FAA Anchorage ARTCC

Response to Pacific Project Action Item PP08-03 “UPR Expansion”

Presented to: Cross Polar Working Group / 19

Date: May 11-15, 2015

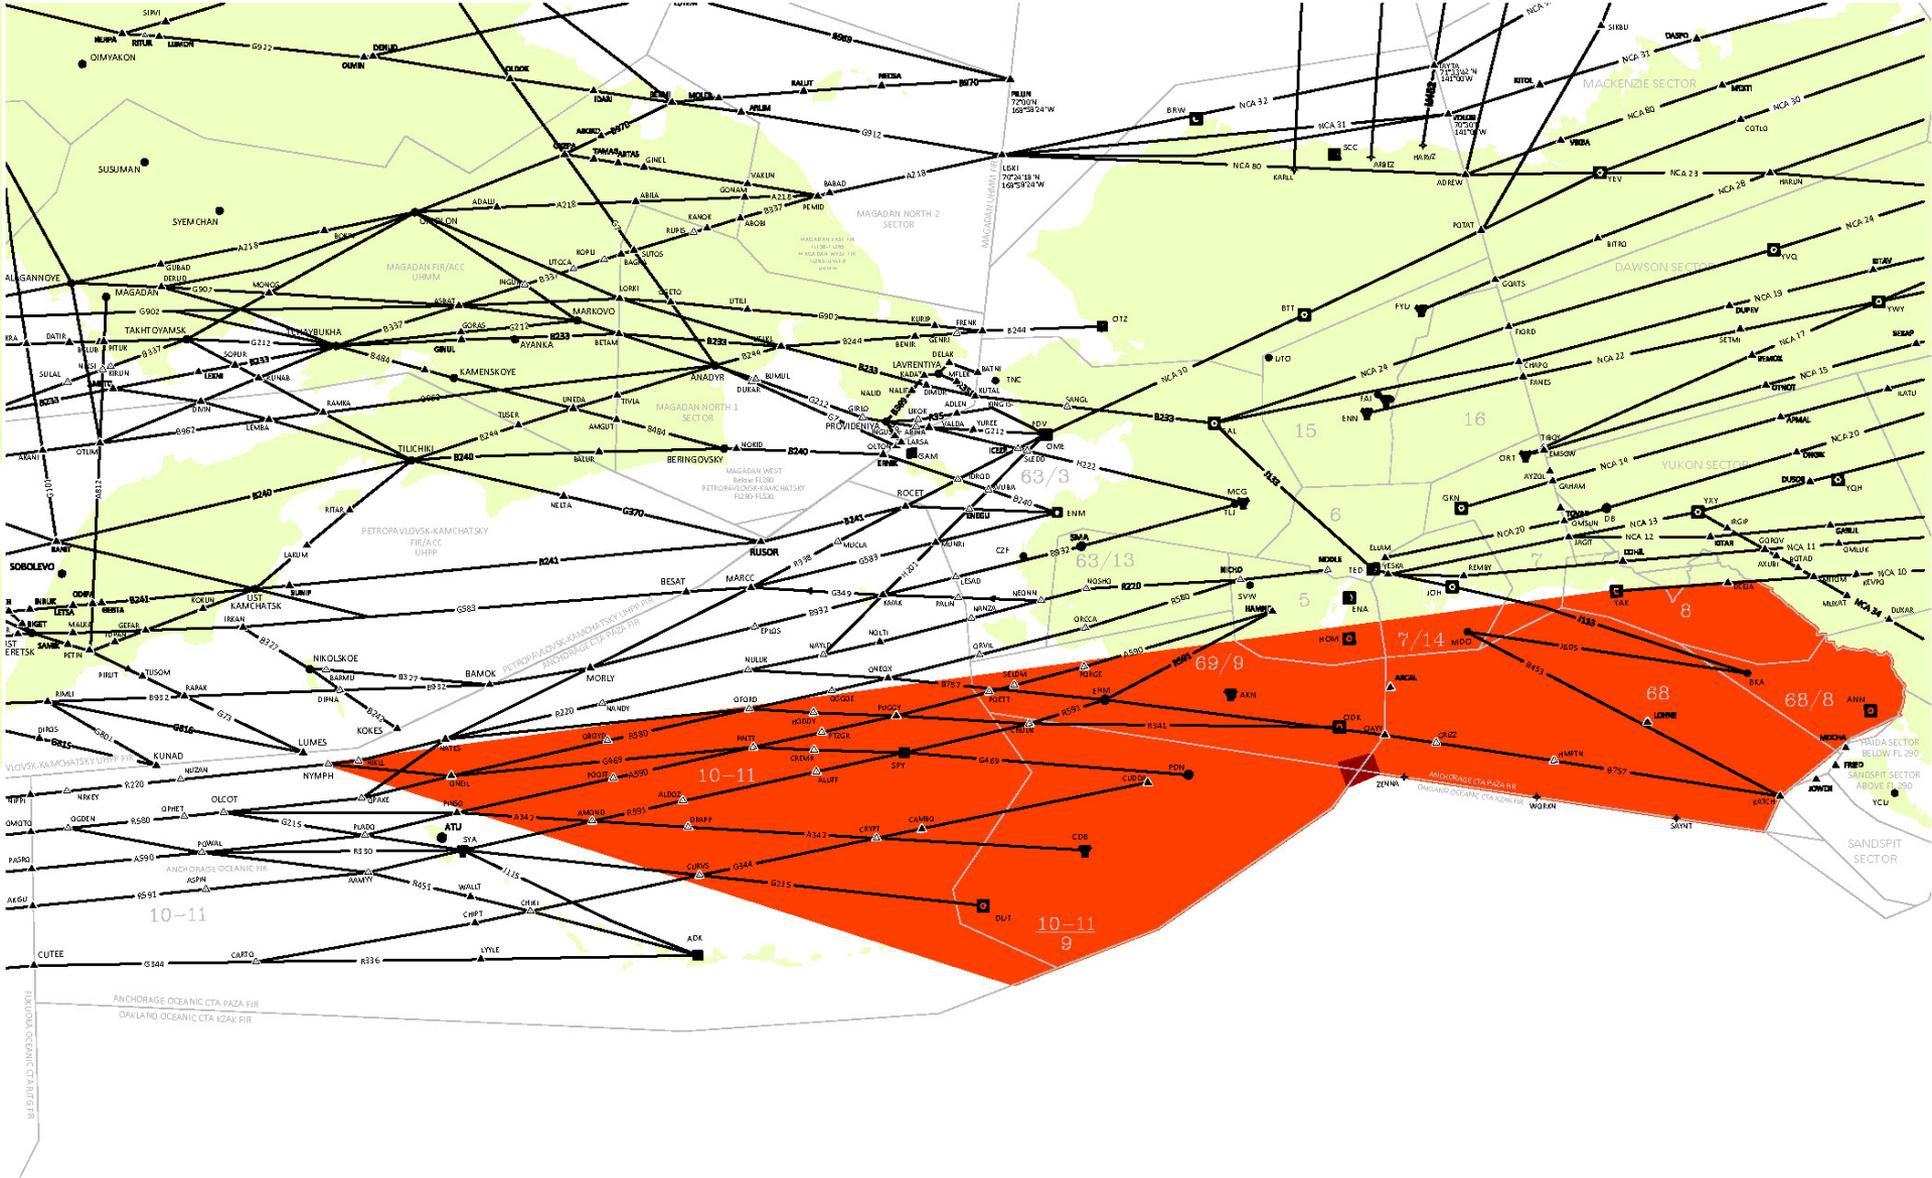
a. R220 - Anchorage ARTCC's UPR NOTAM restricted UPR aircraft to join NOPAC route R220 no further west than position NATES (unless the aircraft was capable of FL400 by 170E in which case it could flight plan direct NIPPI). The action group determined that for aircraft entering PAZA airspace over, or south of, Yakutat (YAK) routing direct NYMPH could be accommodated. Anchorage ARTCC's UPR NOTAM was modified accordingly.

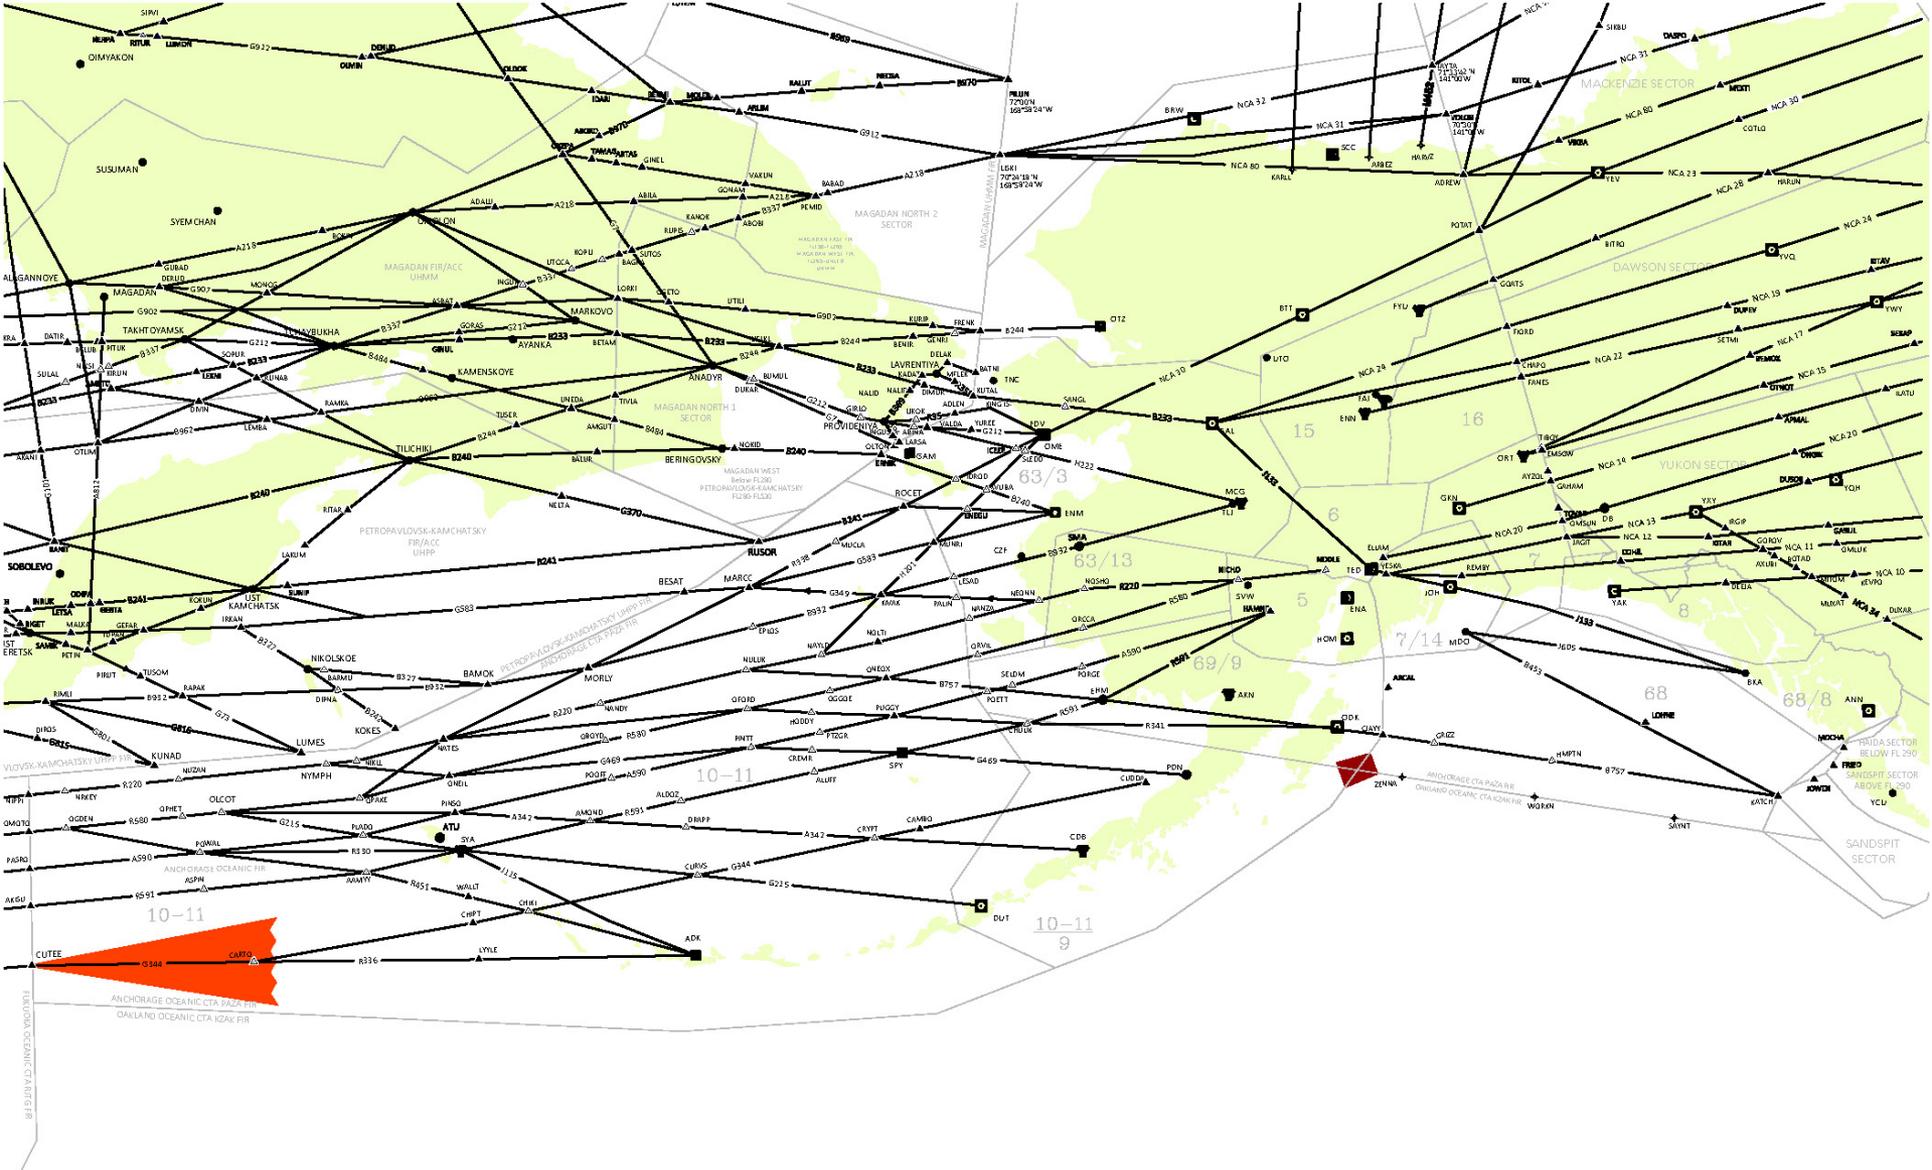
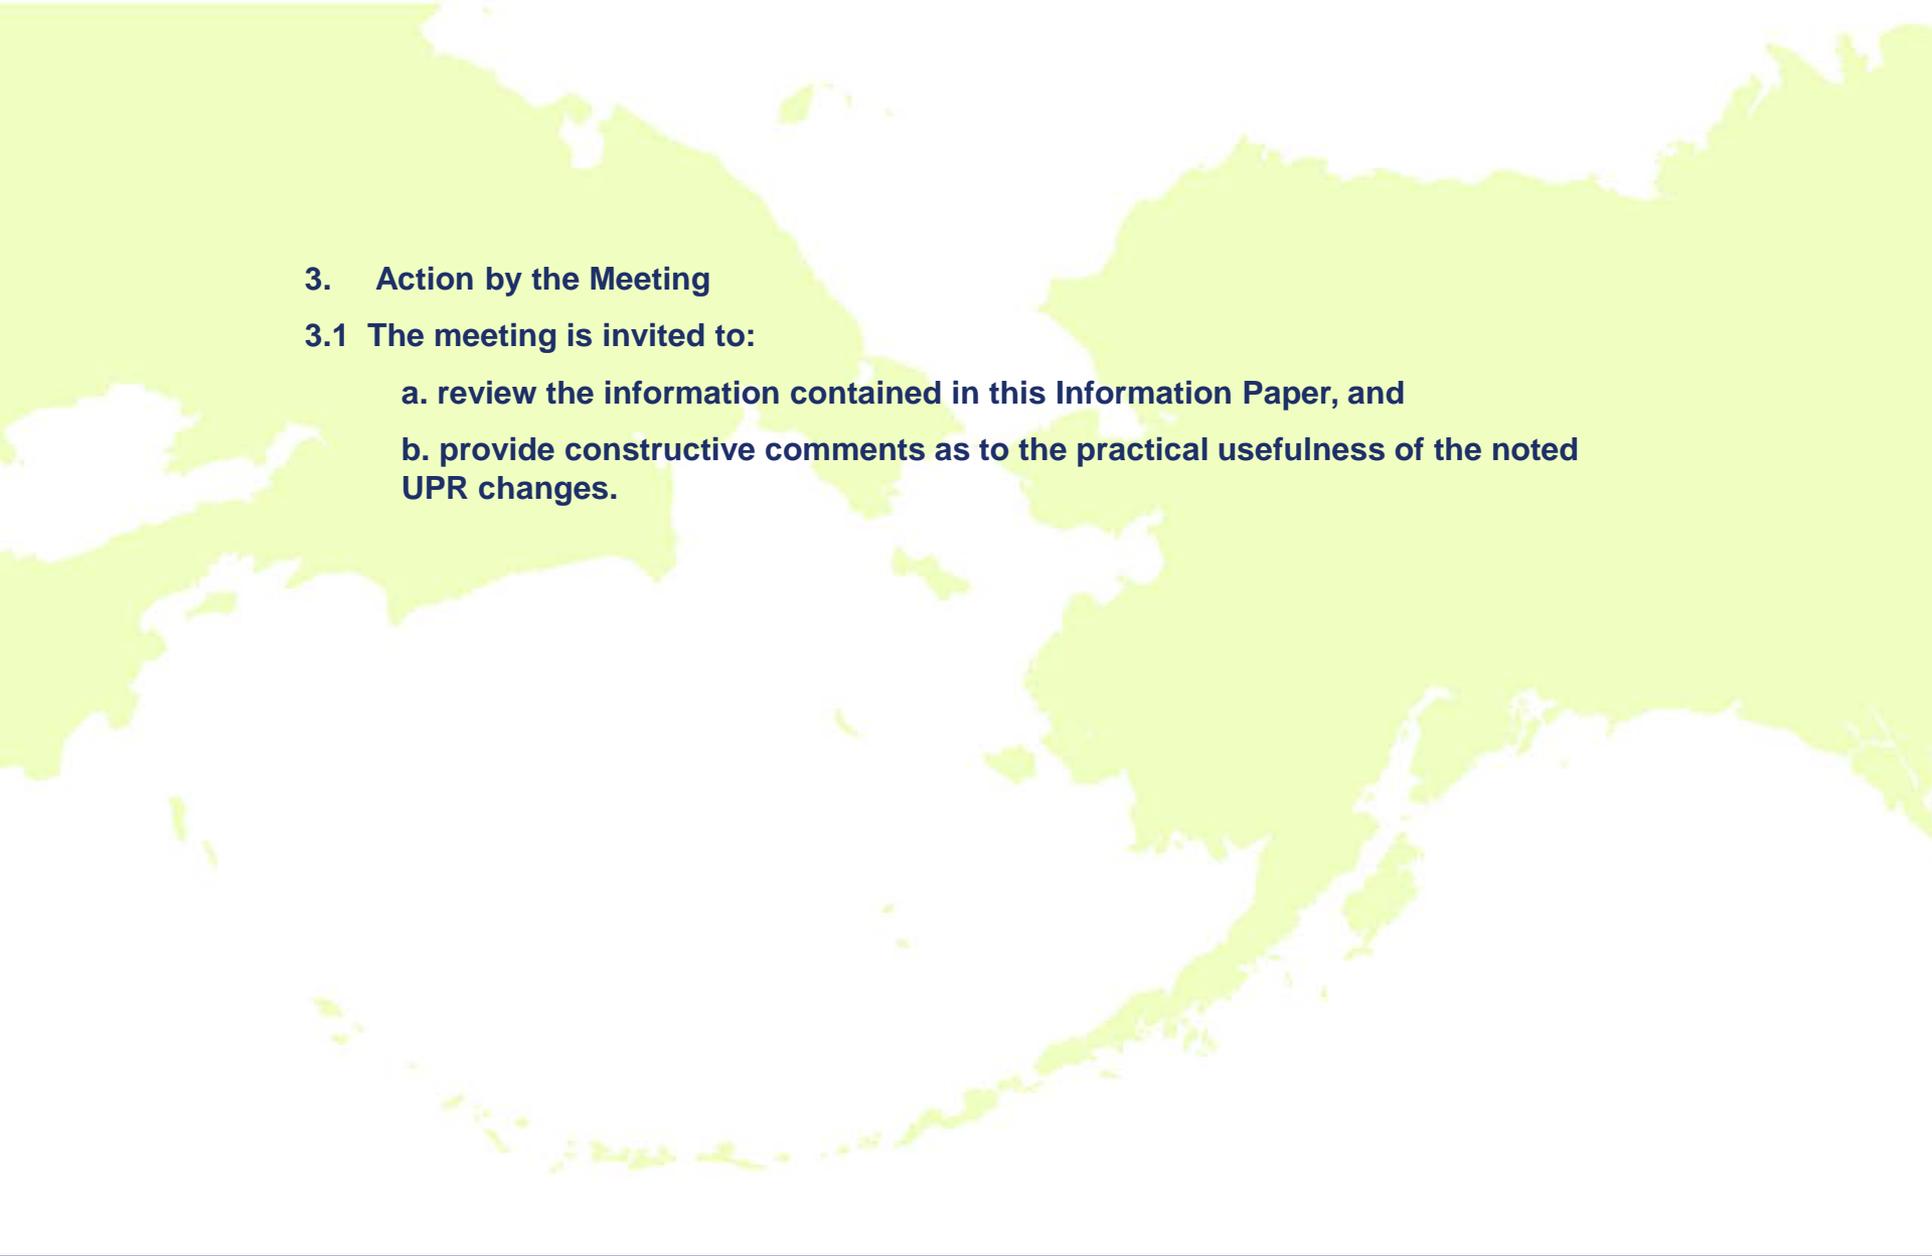
b. R580 - Similar to the above, Anchorage's UPR NOTAM restricted UPR aircraft to join R580 no further west than OPAKE, (except those aircraft able FL400 by 170E which could flight plan direct OMOTO). The action group found that a routing on or south of a YAK direct OLCOT line was acceptable and the UPR NOTAM was modified accordingly.

c. G344 – The action group found the existing UPR restrictions for Eastbound G344 traffic too complex and needed only to ensure UPR aircraft did not cross the Fukuoka / Anchorage FIR and then too abruptly cross the Anchorage / Oakland FIR. The UPR NOTAM was modified to state that eastbound G344 UPR traffic must route via CUTEE then direct 48N170E, or any point north of 48N170E, thence via UPR.
